FIELD ENGINEERING BULLETIN

VOLUME II PART	7
REFERENCE NUMBER	70082
SHEET NUMBER	1 of 3
MODEL NUMBER	AG-350
DATE OF ISSUE	12-15-65
DISTRIBUTION:	C 39, D 1
	Mailing #65-10-14

TITLE ELIMINATION OF POSSIBLE OVER-RECORDING**I** APPLICABILITY:

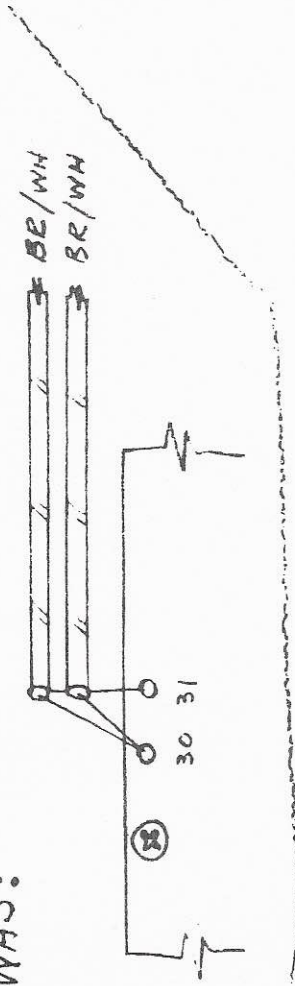
- A. Replace Q23 with 2N2219 or Ampex Catalogue Number 014-247.
- B. Replace 1CR11 and 1CR12 with 1N3277 or DI1151, Ampex C/N 013-157.
- C. Modify output circuit per attached instructions.

AG-350
RECORD CIRCUIT MODIFICATION

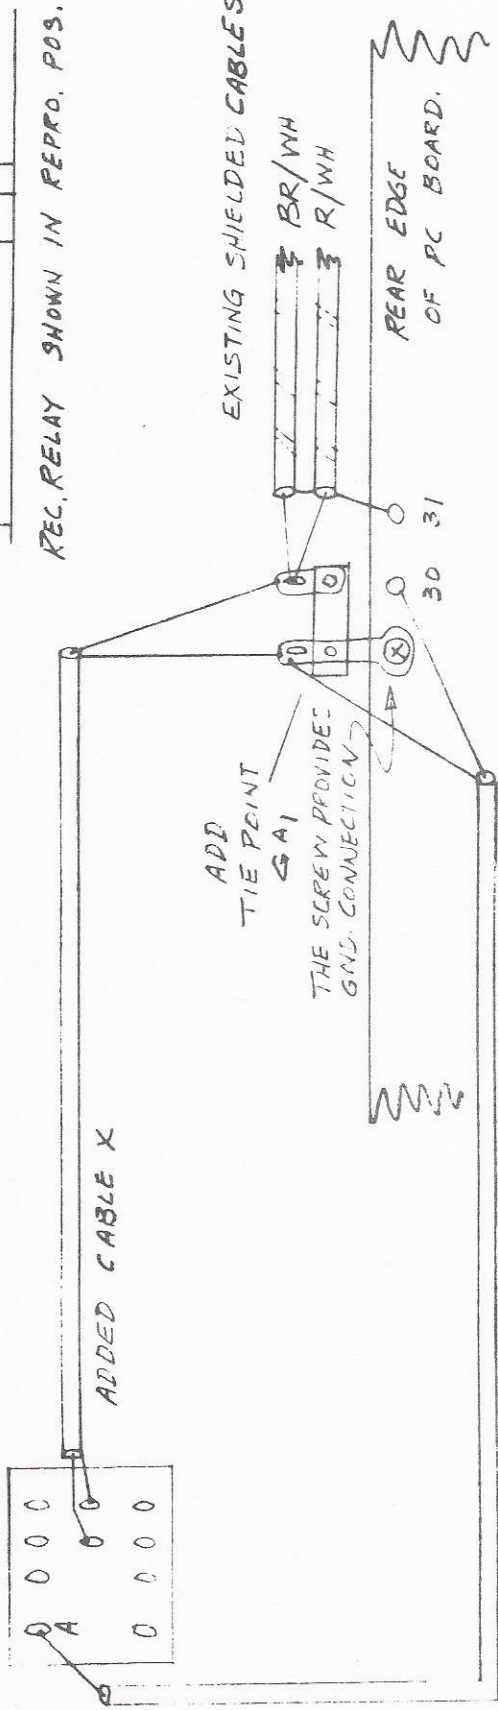
To eliminate the slow voltage decay time in the record amplifier B+ voltage. Slow B+ decay has occasionally caused over-recording when going from record to rewind mode.

The attached diagram illustrates a modification which should cure most over-recording problems. This circuit puts a section of the record relay (3K2) in the record head circuit, which opens the head and shorts the amplifier to ground. This will eliminate the voltage decay time in the record amplifier. A factor which causes this slow decay time is a high leakage 2N697 (IQ23).

1. Lift center conductor of two shielded wires connected to terminal 30 on the rear edge of printed circuit board.
2. Install tie point A₁ under screw next to terminal 30.

3. Connect two center conductors lifted from terminal 30 (Step 1) to tie point ungrounded lug as shown in illustration.
4. Connect a new piece of single conductor shielded cable* to tie point -- shield to ground lug and center to terminal on which two centers are connected. (Step 3)

5. Route the cable along edge of board, at the back of the pan and up the side toward the front, under the heat sync, and past the relay; then up and loop back down to relay terminals.

6. Connect shield to outer terminal of center row and center to the next terminal as shown in illustration (Cable X).
7. Connect a second new piece of single conductor shielded cable -- center to terminal "A" with shield floated.

8. Route the second piece of cable back along the first (Reverse of Step 5).
9. Connect the center conductor to terminal 30 of printed circuit board and shield to ground lug of tie point as shown in illustration.

NOTE: IF 2-CONDUCTOR SHIELDED CABLE IS AVAILABLE, THE SECOND WIRE IS CONNECTED FROM TERMINAL 30 OF THE BOARD TO TERMINAL A OF THE RELAY, AND CABLE Y IS NOT USED.
